## ***Ducted Systems Technical Services Service Letter***

Letter: **YS-008-2020**

Subject: **ECM outdoor fan motor – part reliability upgrade**

Product: YCG, TCG, TC7B, CC7B, RAC17L

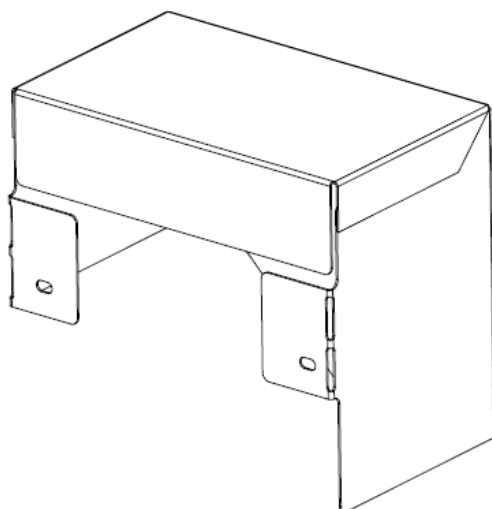
The intention of this letter is to advise use of an alternate ECM outdoor fan motor service part in the above mentioned model families. Soon, equipment production will also switch to the alternate ECM motor. This new (alternate) motor was qualified and chosen as a product and service part enhancement due to a higher than normal outdoor motor failure rate on what is currently used. The new ECM motor has gone through all the normal testing required, as well as some additional testing methods to compare it to what is currently used. These additional tests were performed to ensure not only us but our customers that the new motor is superior to what is currently utilized.

The new ECM fan motor is offered several different ways. There is a kit consisting of a motor and programmed motor module. The motor can be ordered as a separate part as well as the programmed module. **The complete kit is required if replacing one of the part numbers listed above.** Once a motor kit has been installed into one of the above listed equipment models, if a motor or module failure occurred, the only part that would need to be replaced is the part that failed. This strategy will cut down on the amount of parts stocked as well as less time performing an equipment repair. See below for new ECM motor kit, module, and motor part numbers.

**Legacy rain shield**

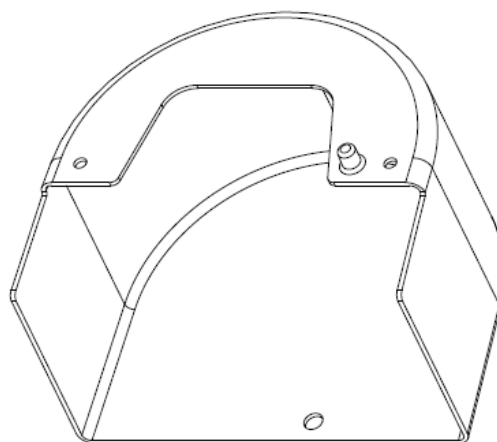
The ECM motor module is attached to the unit block off panel that is located below the unit control panel. It is protected from weather with a rain shield. One mode of module failure we discovered was moisture ingress into the ECM module. In some cases we found that the rain shield was installed upside down therefore no weather protection was provided by the rain shield. A new rain shield was designed and implemented into production in April of 2020. The new rain shield has a feature built into it that does not allow it to be installed incorrectly. The new rain shield is available as a service part however it is not backwards compatible with units that were not built with it nor is it ever needed as a service part. If a customer was to find the existing rain shield installed incorrectly, it can simply be placed in the correct position that will protect the ECM motor module. Images of the rain shields are shown below.
